**Flood Control Project Maintenance  
Levee Inspections**

**Fall 2018 Levee Maintenance Deficiency Summary Report**

**Flood Control Project Maintenance  
Levee Inspections****LMA District Cover Sheet****Fall 2018 Levee Inspection Results****Reclamation District No. 0501 Ryer Island**

**Reclamation District No. 0501 Ryer Island**

Photo 1 of 3 : UCIP\_FA\_2018\_50020\_75648.jpg

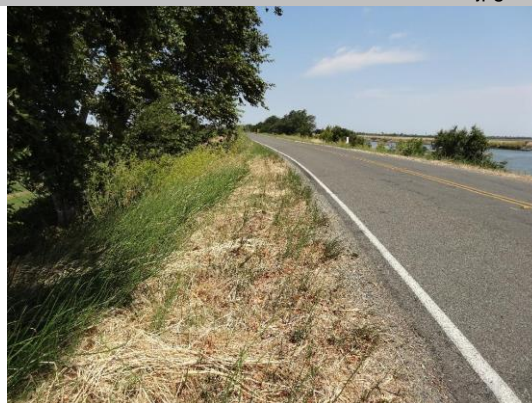
Comment Code					
Inspector Comment					
FS_ID:50020 DS_ID:21034 EP_NO: N/A Repair Type: Non-Urgent Crossing Status: Found UCIP Comments: 8/22/2016 Crossing has been downgraded from Urgent to Non-Urgent -- no evidence of damage to levee is present. Dense vegetation limits the inspector's visibility to identify signs of pipe failure (leaks) through he slope. Recommend removing vegetation along pipe alignment to conduct proper inspection of structure and appurtenances. Also will need to coordinate with owner to determine if permit was obtained for the modifications made to crossing (PVC pipe sleeved through existing pipe). (DWR UCIP - omagana)4/21/2015 Unauthorized PVC pipe. Annular space not grouted. 14-inch pipe open on both ends. (DWR UCIP - omagana) FIELD_STRUCT_DESC: 14-inch steel irrigation siphon pipe through the levee, 3.2 feet below the crown. 10-inch polyvinyl chloride (PVC) pipe sleeved through the 14-inch pipe. Siphon breaker on the landside (LS) shoulder. [Additional Reference(s): DWR Levee Log, 2005. USACE Sacramento O&M Manual 105, April 1959, (HLM 1.0)]. FS Date: 8/22/2016

Photo 3 of 3 : UCIP\_FA\_2018\_50020\_75645.jpg

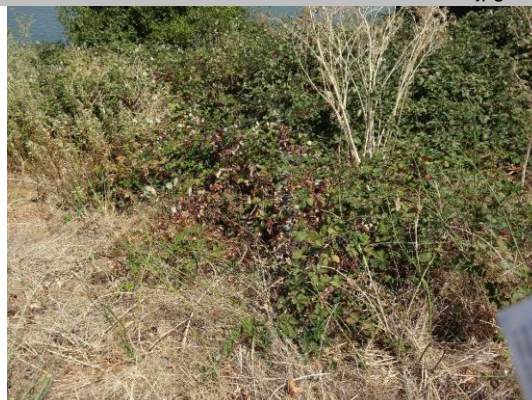
Comment Code						
Inspector Comment						
FS_ID:50020 DS_ID:21034 EP_NO: N/A Repair Type: Non-Urgent Crossing Status: Found UCIP Comments: 8/22/2016 Crossing has been downgraded from Urgent to Non-Urgent -- no evidence of damage to levee is present. Dense vegetation limits the inspector's visibility to identify signs of pipe failure (leaks) through the slope. Recommend removing vegetation along pipe alignment to conduct proper inspection of structure and appurtenances. Also will need to coordinate with owner to determine if permit was obtained for the modifications made to crossing (PVC pipe sleeved through existing pipe). (DWR UCIP - omagana)4/21/2015 Unauthorized PVC pipe. Annular space not grouted. 14-inch pipe open on both ends. (DWR UCIP - omagana) FIELD_STRUCT_DESC: 14-inch steel irrigation siphon pipe through the levee, 3.2 feet below the crown. 10-inch polyvinyl chloride (PVC) pipe sleeved through the 14-inch pipe. Siphon breaker on the landside (LS) shoulder. [Additional Reference(s): DWR Levee Log, 2005. USACE Sacramento O&M Manual 105, April 1959, (HLM 1.0)]. FS Date: 8/22/2016

Dense vegetation covers WS--pipe slightly visible through vegetation.

Photo 1 of 1 : FA\_2018\_RD0501\_169\_21\_20181106\_00069.jpg

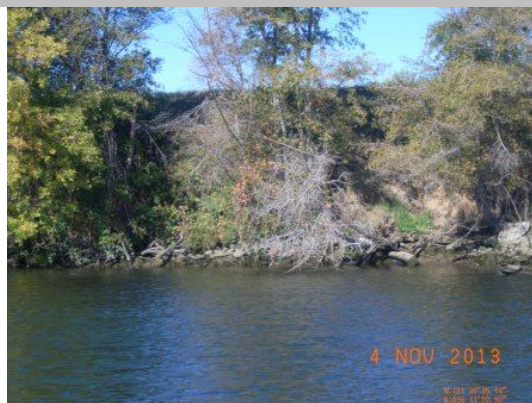
LM Start	5.77	Rating **	M	Issue No.	21
LM End	5.84	Issue Type +	Ma	Location *	WS
Category	Supplemental			GPS Latitude/Longitude	
				Start	End
Item	2017 USACE Erosion Survey, DRAFT			38.190001°	38.189311°
				-121.643160°	-121.643917°
DWR ID	DWR_RD0501_01_f_2018_21				
Comment Code					
Inspector Comment					
2017 Site ID: STM 15.7 R					
Status: Eroding					
2017 Field Notes: No observed change.					
Site History: 2008 - Overstepped levee section with multiple small pockets of erosion 10 - 20 ft wide. 2013 - Site has fresh erosion and taller vertical sections.

Photo 3 of 3 : UCIP\_FA\_2018\_53353\_58966.jpg

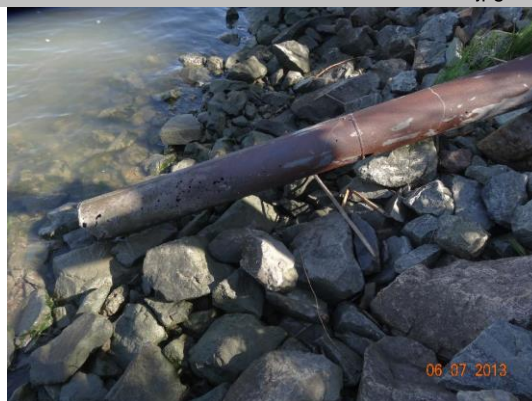
Comment Code						
Inspector Comment						
FS_ID:53353 DS_ID:21092 EP_NO: 3703 Repair Type: Urgent Crossing Status: Found UCIP Comments: 07/24/2018 Same as last inspection. Could not inspect WS due to overgrown vegetation. Keeping Urgent due to pipe integrity concerns and threat to levee integrity (D. Sanoski - DWR UCIP).8/22/2016 Same as last inspection -- pipe is deteriorating and breaking apart (visible on WS). (DWR UCIP - omagana)6/07/2013 Deteriorated pipe with holes present at intake. Dense vegetation limits the inspector's visibility to identify signs of pipe failure (leaks) through the slope. Recommend removing vegetation along pipe alignment to conduct proper inspection of structure and appurtenances. If crossing is no longer used --owner will need coordinate with CVFPB to address crossing. Need to coordinate with DWR Inspector and CVFPB. (DWR UCIP - omagana) FIELD_STRUCT_DESC: *ABANDONED* 8-inch steel irrigation siphon pipe through the levee, 1.7 feet below the crown. Siphon breaker on the apex of the pipe on the landside (LS) shoulder. Pipe discharges into a concrete sump near the LS toe. Pipe is exposed along the LS slope. Second 8-inch pipe approximately 1 foot apart is visible on the LS. Pipe is also visible on the waterside (WS). (Retention of an existing 8-inch siphon pipe through the levee authorized under Permit No. 3703, 1961 - Enzo Guidi). [Additional Reference(s): DWR Levee Log, 2005]. FS Date: 7/24/2018 3:43:00 PM

Deteriorated pipe with visible holes through pipe wall.

Photo 1 of 3 : UCIP\_FA\_2018\_44865\_58975.jpg

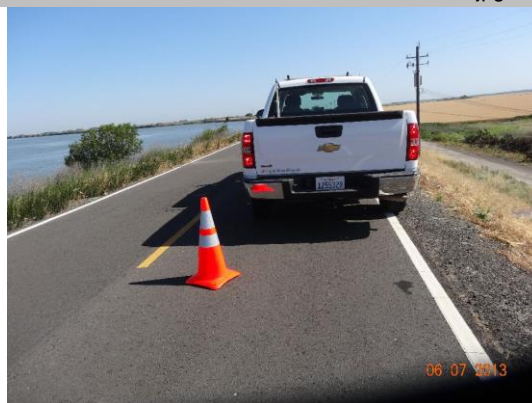
Comment Code						
Inspector Comment						
FS_ID:44865 DS_ID:21038 EP_NO: 2817 Repair Type: Non-Urgent Crossing Status: Found UCIP Comments: Dense vegetation limits the inspector's visibility to identify signs of pipe failure (leaks) through the slope. Recommend removing vegetation along pipe alignment to conduct proper inspection of structure and appurtenances. Scour hole located on waterward side. FIELD_STRUCT_DESC: 20-inch steel drainage discharge pipe sleeved through a 24-inch steel pipe through the levee, 9 feet below the crown. Flap gate on the waterside (WS) end. Cutoff wall around the pipe at each shoulder. Pipe exposed along both slopes. Rock revetment on the WS slope. Berm on the WS is over 20 feet. (Plans to install a drainage pipe through the levee authorized under Permit No. 2817, 1958 - Reclamation District No. 501 [RD0501]). [Additional Reference(s): DWR Levee Log, 2005]. FS Date: 6/7/2013

Photo 1 of 2 : UCIP\_FA\_2018\_32541\_59008.jpg

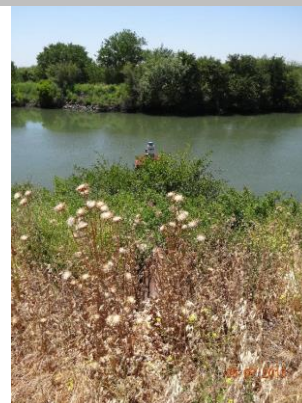
Comment Code					
Inspector Comment					
FS_ID:32541 DS_ID:21071 EP_NO: N/A Repair Type: Non-Urgent Crossing Status: Found UCIP Comments: --Contact owner--Dense vegetation limits the inspector's visibility to identify signs of pipe failure (leaks) along the waterward and landward slopes. Recommend removing vegetation along pipe alignment to conduct proper inspection of structure and appurtances. Walkway and siphon breaker not found. FIELD_STRUCT_DESC: 12-inch reinforced concrete irrigation discharge pipe through the levee, 2.5 feet below the crown. Cutoff wall around the pipe at the center of the levee. Siphon breaker at the apex of the pipe on the shoulder. Pump on a pile structure in the stream. Walkway access to pump. [Additional Reference(s): DWR Levee Log, 2005. USACE Sacramento O&M Manual 105, April 1959, (HLM 5.1)]. FS Date: 6/7/2013

Photo 3 of 3 : UCIP\_FA\_2018\_46834\_33467.jpg

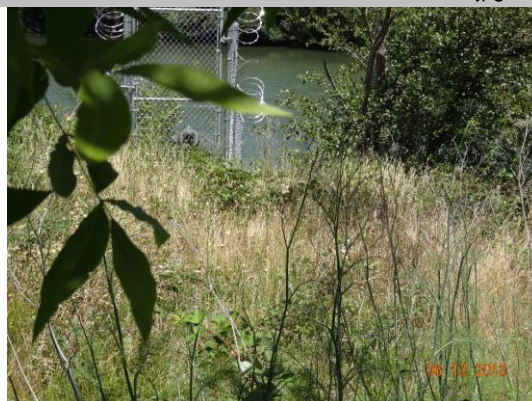
Comment Code						
Inspector Comment						
FS_ID:46834 DS_ID:21061 EP_NO: N/A Repair Type: Non-Urgent Crossing Status: Found UCIP Comments: 11/19/2015 DWR Inspector (H. Phillips) coordinated with LMA superintendent and the owner for this crossing is Walter Koeing, APN No. 042220040. According to LMA superintendent owner installed filter system with fence on landward side and fence around pump in 2012. Pipe not replaced in 2012, this pipe would be a good candidate for internal inspection since the installation date for this crossing was recorded as 1946.06/13/2013 Conduit visible on landward side; new gate on WS toe; filtration system with security fence; Pipe has been upgraded--need permit authorizing work and owner. Dense vegetation limits the inspector's visibility to identify signs of pipe failure (leaks) along the waterward slope. Recommend removing vegetation along pipe alignment to conduct proper inspection of structure and appurtenances. FIELD_STRUCT_DESC: 8-inch steel irrigation discharge pipe through the levee, 3.7 feet below the crown. Siphon breaker and service pole on the landside (LS) slope. 2-inch electrical conduit of an unknown material runs parallel to the 8-inch steel pipe. Pump in a pump house on the waterside (WS) slope. [Additional Reference(s): DWR Levee Log, 2005. USACE Sacramento O&M Manual 105, April 1959, (HLM 8.0)]. FS Date: 6/13/2013

Photo 1 of 3 : UCIP\_FA\_2018\_50025\_59039.jpg

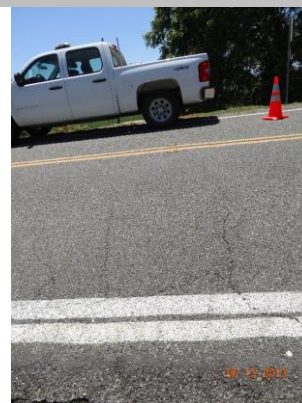
Comment Code					
Inspector Comment					
FS_ID:50025 DS_ID:21063 EP_NO: 11812 Repair Type: Non-Urgent Crossing Status: Found UCIP Comments: 8/22/2016 Crossing has been downgraded from Urgent to Non-Urgent no levee damage appears to be present along pipe alignment. There appears to be an erosion site adjacent to this crossing. Need to coordinate with DWR Inspectors. (DWR UCIP - omagana)6/07/2013 Open cut section of levee on LS slope 8 foot wide--repair work needed. Abandoned pump on waterward berm. Dense vegetation--Recommend removing vegetation along pipe alignment to conduct proper inspection of structure and appurtenances on waterward side. (DWR UCIP - omagana) FIELD_STRUCT_DESC: 14-inch coated steel irrigation discharge pipe and a 1.25-inch electrical conduit of an unknown material through the levee, both 3 feet below the crown. Cutoff wall around the pipe and conduit at the center of the levee. Siphon breaker at the apex of the pipe on the landside (LS) shoulder. Slant pump on the waterside (WS) slope. Discharge structure at the LS toe. Rock revetment on the WS slope. (Plans to replace a 14-inch irrigation pipe through the levee crown and a slant pump on the riverbank authorized under Permit No. 11812, 1976 - Harry H. Rasmussen). [Additional Reference(s): DWR Levee Log, 2005]. FS Date: 8/22/2016

Photo 2 of 3 : UCIP\_FA\_2018\_32551\_59072.jpg

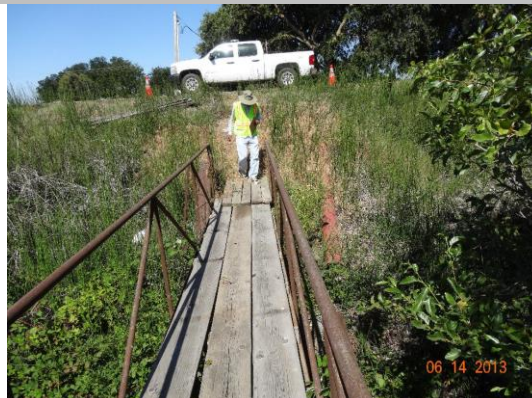
Comment Code						
Inspector Comment						
FS_ID:32551 DS_ID:21074 EP_NO: N/A Repair Type: Non-Urgent Crossing Status: Found UCIP Comments: Unable to determine status of crossing. Pipe visible on waterward side--could be the pipe that was supposed to be removed under permit number 13983 (1985). Also present is a 1.5 inch conduit along the 8 inch pipe. Need to coordinate with owner. FIELD_STRUCT_DESC: 8-inch steel irrigation discharge pipe through the levee, 6.4 feet below the crown. Pump on a pile structure in the stream. Service pole on the landside (LS) slope. (8-inch pipe should have been removed and replaced with a 12-inch pipe authorized under Permit No. 13983, 1984 - Mrs. John Thomas). [Additional Reference(s): DWR Levee Log, 2005. USACE Sacramento O&M Manual 105, April 1959, (HLM 1.3)]. FS Date: 6/13/2013

Abandoned pipe to the right of walkway.

Photo 3 of 3 : UCIP\_FA\_2018\_32553\_59080.jpg

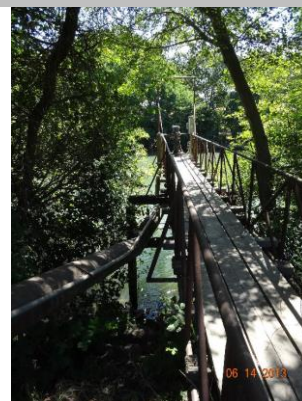
Item	DWR UCIP Field Study			38.260407°	38.260407°
				-121.601365°	-121.601365°
DWR ID	21077				
Comment Code					
Inspector Comment					
FS_ID:32553 DS_ID:21077 EP_NO: N/A Repair Type: Non-Urgent Crossing Status: Found UCIP Comments: Dense vegetation limits the inspector's visibility to identify signs of pipe failure (leaks) along the waterward and landward slope. Recommend removing vegetation along pipe alignment to conduct proper inspection of structure and appurtenances. FIELD_STRUCT_DESC: 14-inch steel irrigation discharge pipe through the levee, 8 feet below the crown. 2-inch electrical conduit of an unknown material through the levee, at an unknown depth. Siphon breaker on the landside (LS) slope. Pump on a pile structure in the stream. [Additional Reference(s): DWR Levee Log, 2005. USACE Sacramento O&M Manual 105, April 1959, (HLM 2.0)]. FS Date: 6/13/2013
